# The LACP MUX machine

This note proposes a further revision of the LACP MUX state machine in P802.1AX-Rev/D0.1<sup>1</sup> Figure 6-22. This aims to bridge the gap between the D0.1 machine and other description of the WTR (Wait To Restore) functionality, correct (what I believe are) some new errors and undesirable features, and explain (what I believe to be) some improved functionality.

Figure 1—The proposed MUX state machine ‘PMUX’

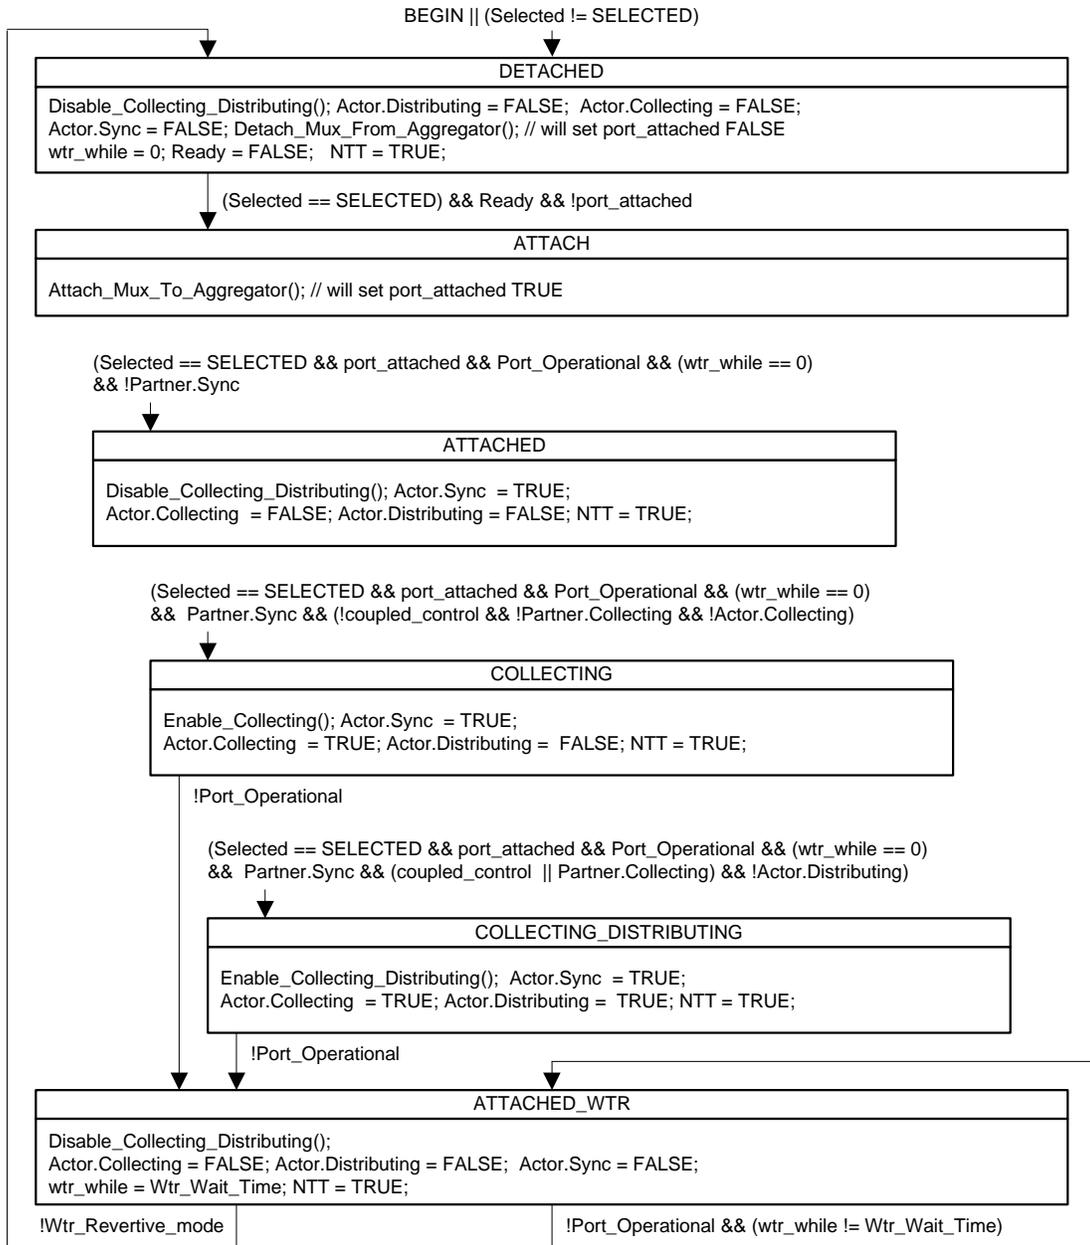
- 1) MUX0.1:DETACHED set NTT conditionally on Actor.Sync being TRUE.

However the first time this state is entered (on BEGIN) Actor.Sync has not yet been initialized, so the setting will be random.

Even if Actor.Sync is FALSE on entry to this state, that seems no particular reason for suppressing transmission, as the Partner may well wish to be informed of changed LAG parameters.

- 2) MUX0.1:ATTACHED\_WTR sets wtr\_revertive (not previously initialized, which is a problem for MUX0.1:Set) to wtr\_revertive\_mode. The function of this flag is to hold the machine in MUX0.1:ATTACHED\_WTR if wtr\_revertive\_mode is FALSE. It thus provides the Selection Logic with another control, in addition to Ready and Selected. I believe that this is unnecessary and an awkward split of functionality between the Selection Logic and the Mux machine. If non-revertive behavior is required PMUX returns the failed Aggregation Port to DETACHED. The Selection Logic will see that return. Apart from port\_attached becoming FALSE, the Selection Logic had previously set Ready (which is cleared in DETACHED) so there is no confusion between !port\_attached because attachment hasn't happened yet and !port\_attached due to attachment, followed by Port\_Operational, followed by !Port\_Operational.

One advantage of the failed non-revertive mode port going to DETACHED is the easier use of STANDBY links (presuming their failure probability is independent) which are then more easily swapped in (rather than changing Select for the failed link and waiting for it to become !port\_attached).

- 3) MUX0.1:ATTACHED\_WTR supports a wait to restore timeout of zero (immediate restoration on Port\_Operational, which I had overlooked in my prior MUX machine proposal), but does so by executing ATTACHED\_WTR continuously. That does not make for easy implementation. PMUX deals with that by using a local, rather than global transitions, to enter ATTACHED\_WTR.

- 4) MUX0.1 uses the abbreviation Set to simplify conditions in the machine. However I have found this a real nuisance as it obscured searches for use of the underlying variables. By avoiding the use of wtr\_revertive, PMUX simplifies these conditions so they can be spelt out in full.

- 5) PMUX allows an Aggregation Port to be attached to an Aggregator without the Selection Logic having to wait for Port\_Operational to become TRUE (or suffering from the undesirable effect of engaging WTR - possibly non-revertive) before the port has come into use for the first time. This is particularly beneficial in the simple cases. It is only after the port has become operational and then failed that PMUX invokes WTR.

- 6) MUX0.1:COLLECTING sets NTT conditionally on Collecting not already being TRUE, but it is possible (as Steve has pointed out) that the state might be entered as a consequence of disabling Distributing, so PMUX sets NTT unconditionally.

PMUX:DETACHED sets NTT unconditionally.

Remove Wrt\_Revertive from the list in 1AX-Rev 6.4.7.
